Drainage Letter/Report

Manley Tract El Paso County, Colorado

April, 2022

El Paso County Project Number Add "VR2310"

Exhibit 6: Existing Plat and Replat

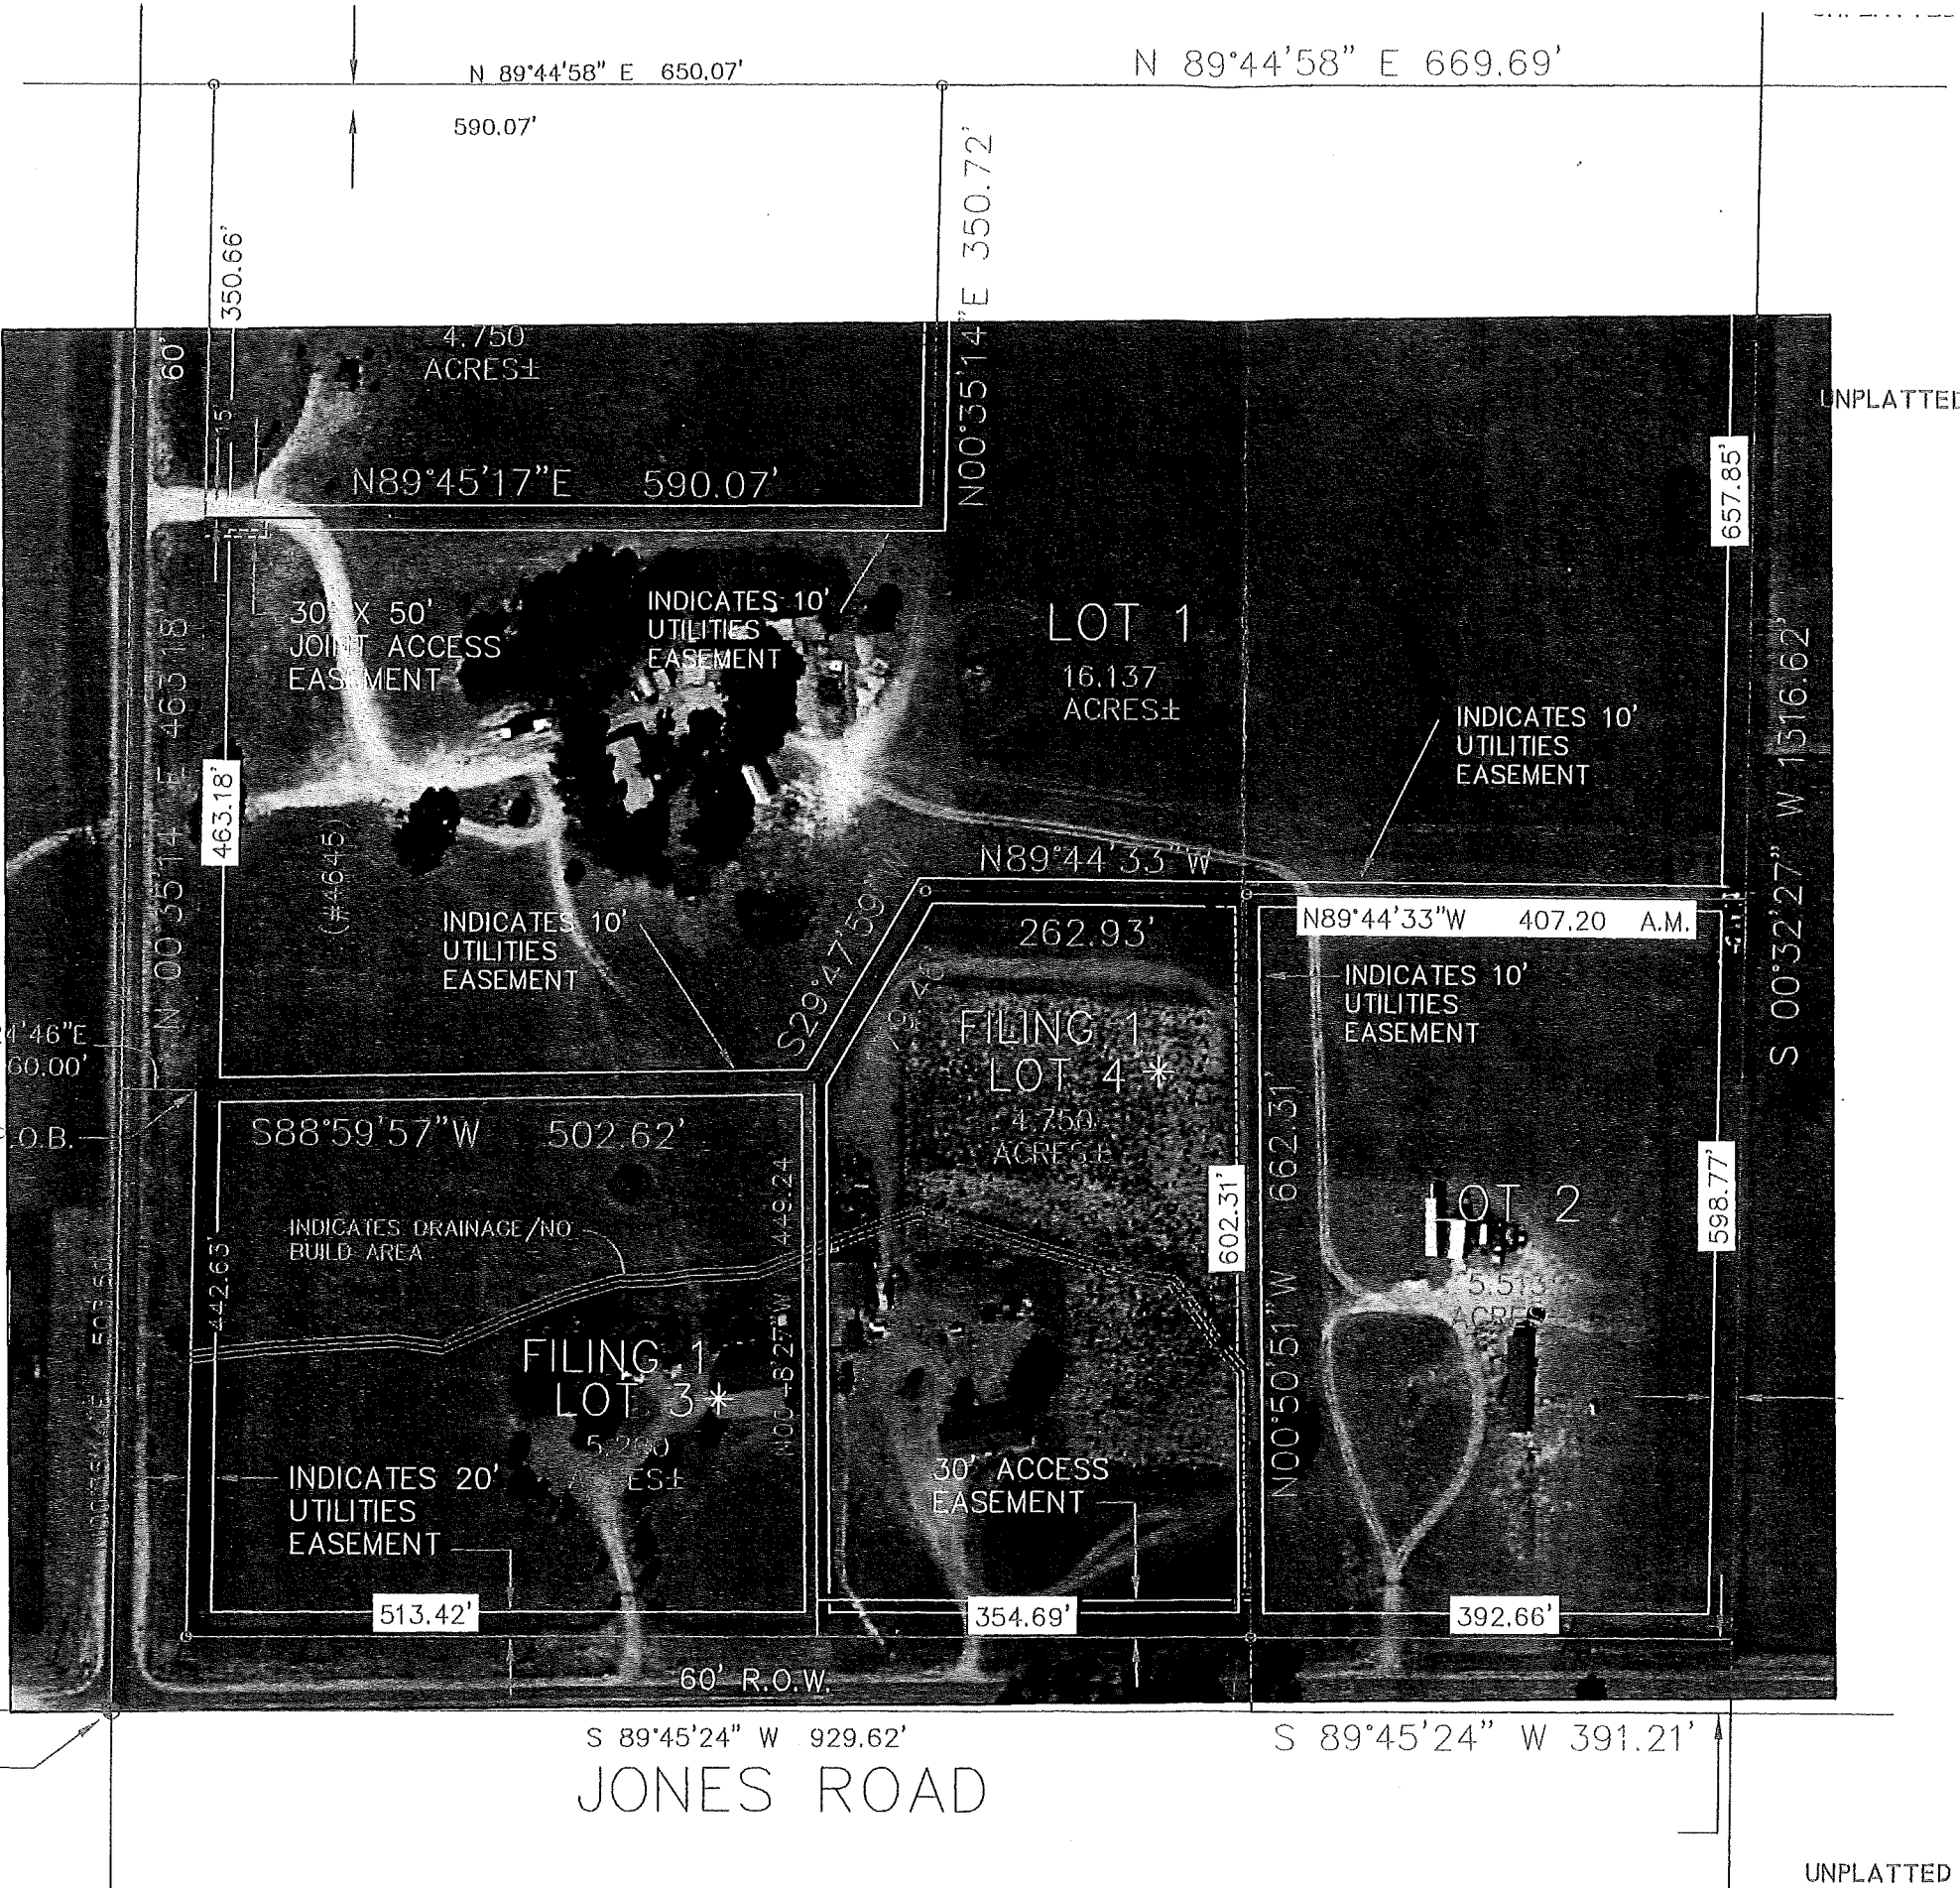
Remove any exhibits from Black Squirrel DBPS as project site is not within that basin.

DRAINAGE PLAN

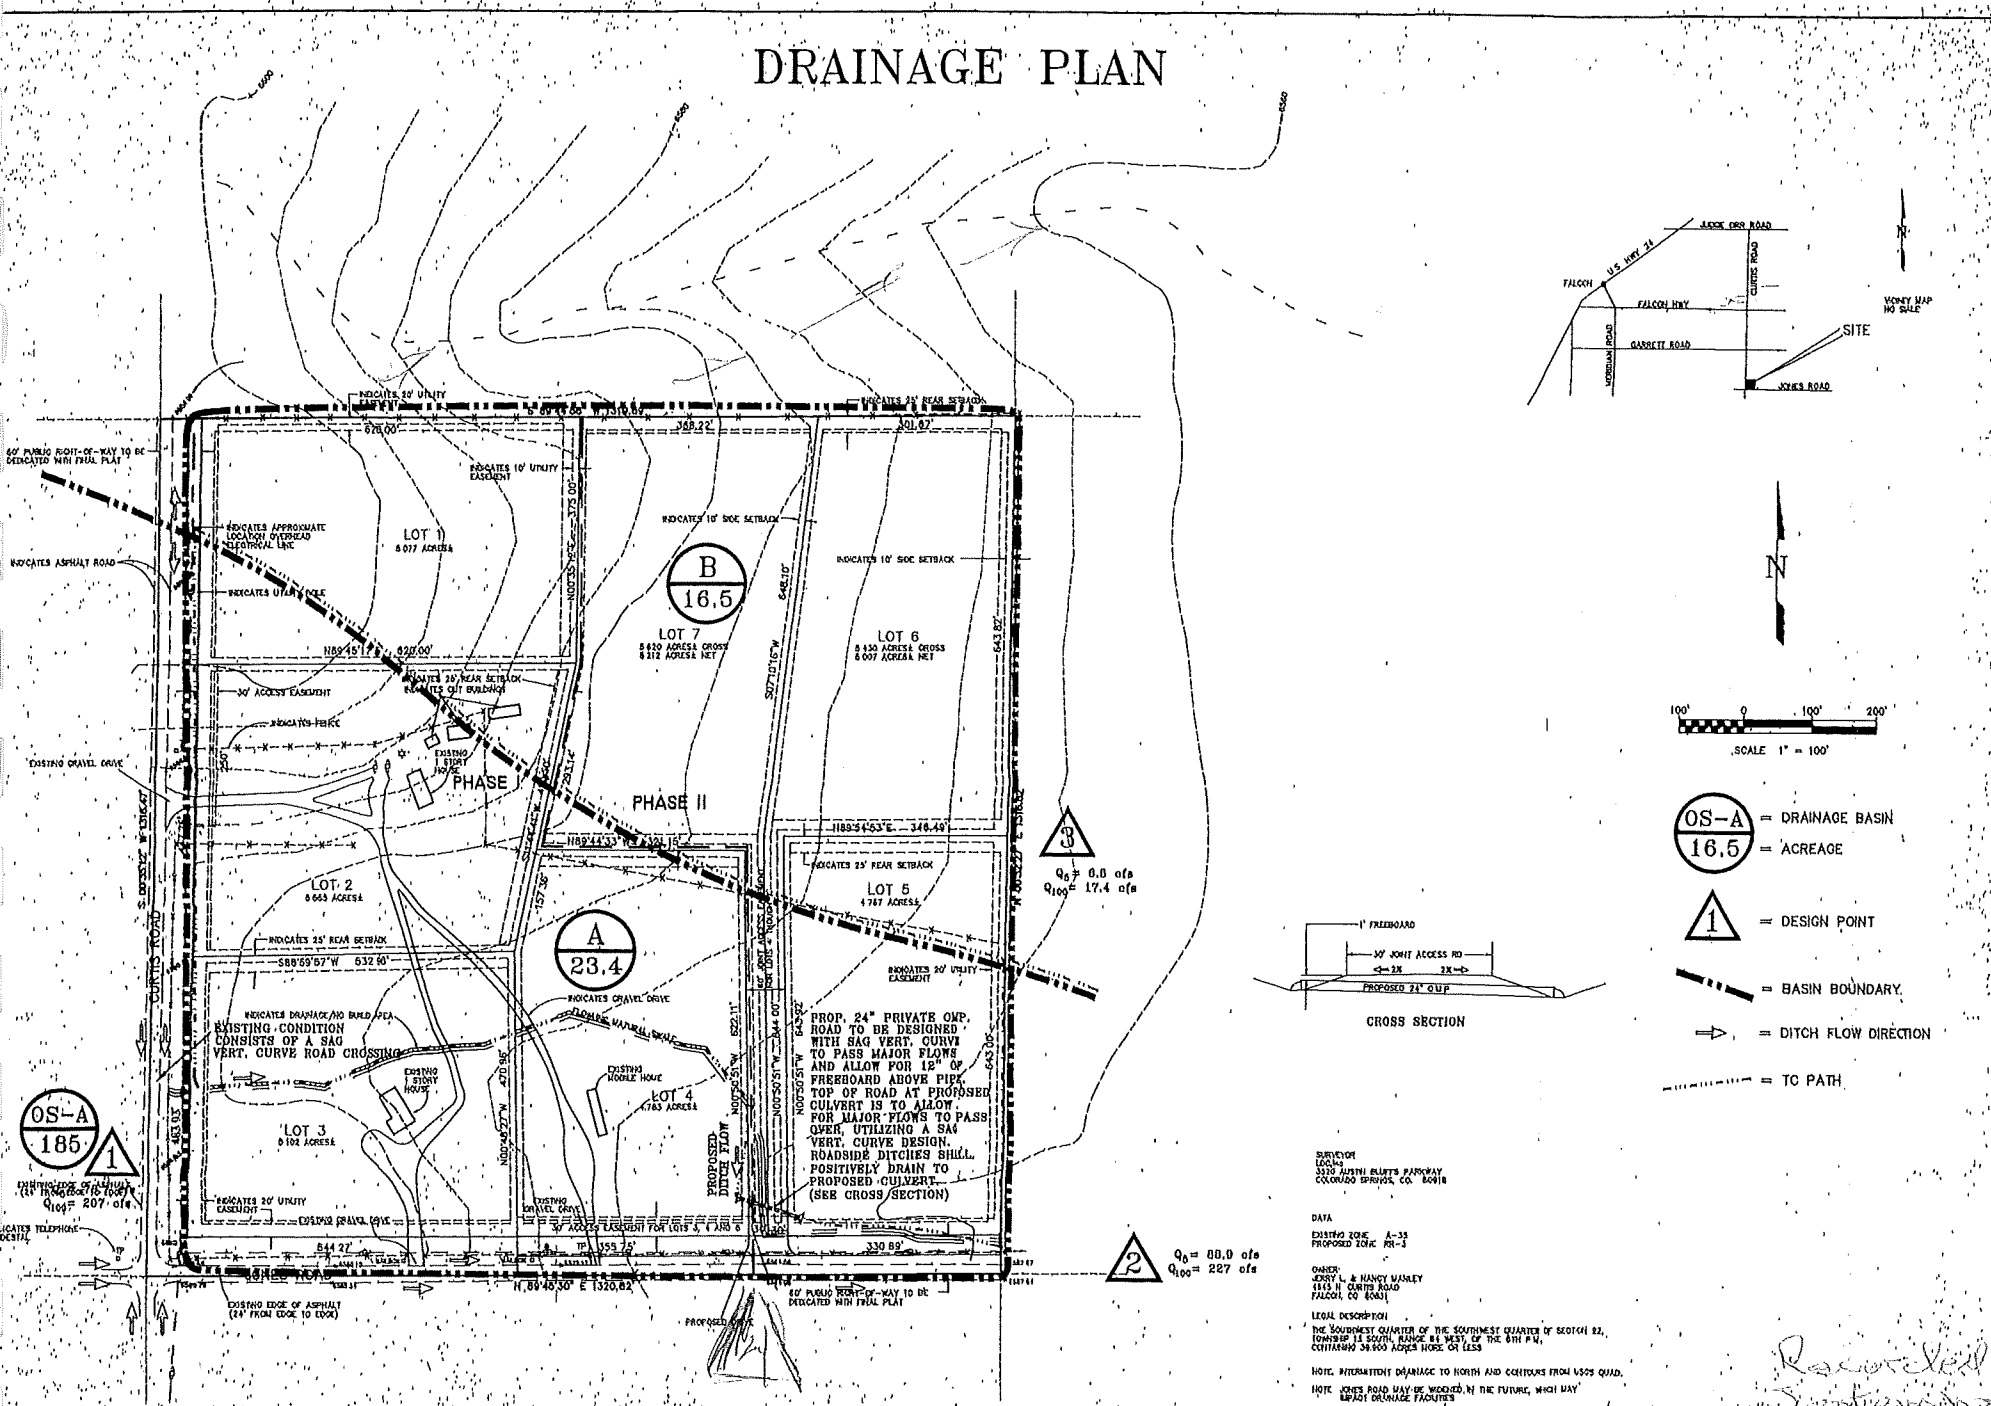
Indicate which report the various pieces in this section came from.

Indicate which drainage report this map came from.

The open channel flow calculator

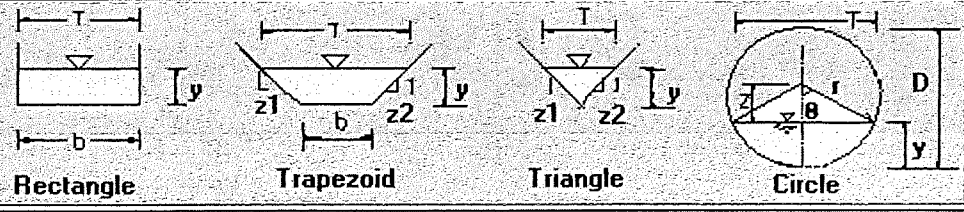
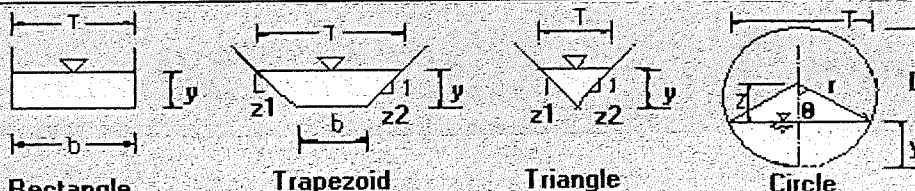
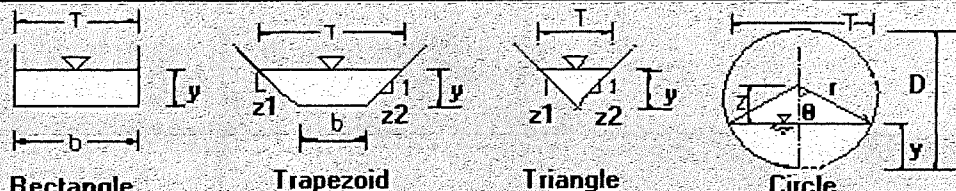
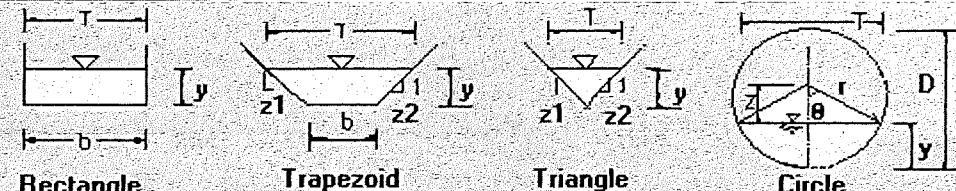
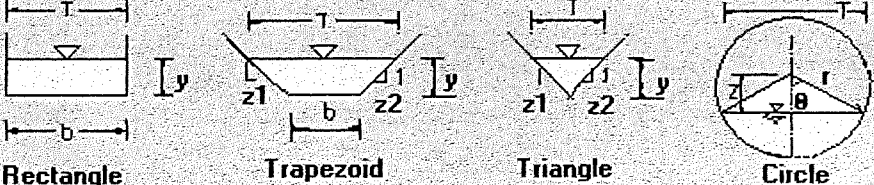
Per DCM Section 10.7, Fr # should be less than 0.9. Address this in the report and explain if existing swales appear to be stable, sufficient vegetation, no erosion, etc and reiterate that flows will not change as no additional improvements are being made. (For all swales)

Label what swale this is for and which storm event
